## AGENDA CITY OF CEDAR FALLS, IOWA PLANNING AND ZONING COMMISSION MEETING WEDNESDAY, JUNE 26, 2019 5:30 PM AT CITY HALL

- TO: Planning and Zoning Commission
- FROM: David Sturch, Planner III Matt Tolan, Civil Engineer II
- **DATE:** June 19, 2019
- SUBJECT: Cherrywood Acres Minor Plat
- REQUEST: Request to approve the Cherrywood Acres Minor Plat Case # MP19-001
- PETITIONER: Anthony Runyan
- LOCATION: 4114 High Street

The property owner at 4114 High Street proposes a lot split to create a lot for a new residential dwelling at the southwest corner of High Street and Union Road. A minor plat is needed to split the original single lot into two lots.

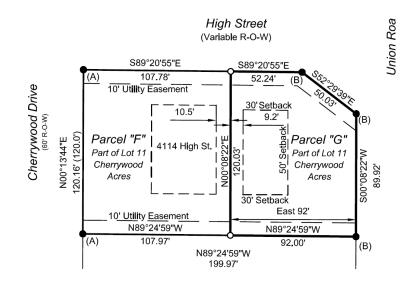
The drawing to the right graphically depicts the lot split and building locations. The building setbacks in the R-1 district require a 30-foot front yard and a 30-foot rear yard area. The side yard areas are 10% of the width of the lot. A 25-foot building line was

established on the plat to serve as a side yard setback along High Street. Since this is a newly created lot, the current R-1 standards must comply with a 30-foot front yard area as well as the remaining setback areas. The existing dwelling at 4114 High Street and the proposed dwelling on Parcel G satisfied the R-1 district setback standards.

By applying the setbacks on this lot, the potential building area for a new dwelling and attached garage is approximately 1,968 square feet. The building envelope is 60' north/south and 32.8' east/west. This building area is similar in size to other dwellings in the neighborhood. The area of both lots will be half the size of the other lots in the neighborhood. The two parcels will still exceed the minimum R-1 lot area standards of 9,000 square feet. Both lots meet all zoning ordinance requirements if subdivided.

## **TECHNICAL COMMENTS**

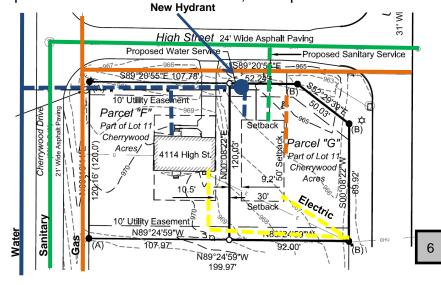
City technical staff, including Cedar Falls Utilities (CFU) personnel, has reviewed the proposed plat. The following items listed below are the technical comments for the development of this plat and proposed home. The solid lines on the plat represent the existing utility service locations and the dashed lines represent the proposed utility service lines.

- 1. The existing underground electric line from the southeast corner of the lot to the existing house must be relocated and buried within the 10-foot utility easement along the south lot line.

- 2. The existing 12" water main lies along the west side of Cherrywood Drive. The plat shows a new water main extension off the existing main extending to a hydrant located east of the existing driveway at 4114 High Street. According to the CFU and Fire Department policy for new development, the water main must be extended to the middle of the lot along High Street for the hydrant, as shown on the previous page. This will provide water service to both the existing dwelling at 4114 High Street and the proposed dwelling. Final fire hydrant and valve placement locations will be part of the construction review.

- 3. Sanitary sewer service will be connected to the existing sewer on High Street.
- 4. Gas service will be connected to the existing gas line on High Street.

- 5. The Cherrywood Acres subdivision was developed with a rural roadway cross-section with no curb and gutter. There are ditches alongside the roadway that carry the stormwater through pipes under the driveways and in field tiles. The proposed driveway will have a culvert for the stormwater in the ditch. If the owner discovers a buried field tile during the construction of the home, that tile must be relocated and rerouted around the building's foundation.

- 6. The proposed driveway off of High Street must be at least 75 feet from the west edge of Union Road.
- 7. There will be no access onto Union Road.

The Community Development Department recommends approval of the Cherrywood Acres Minor Plat with the following conditions:

1. Extend the water main across the north lot line for the placement of the hydrant ear

of the existing driveway.

- 2. The existing home must be connected to the water main.
- 3. Any comments or direction specified by the Planning and Zoning Commission.
- 4. Conform to all city staff recommendations and technical requirements.
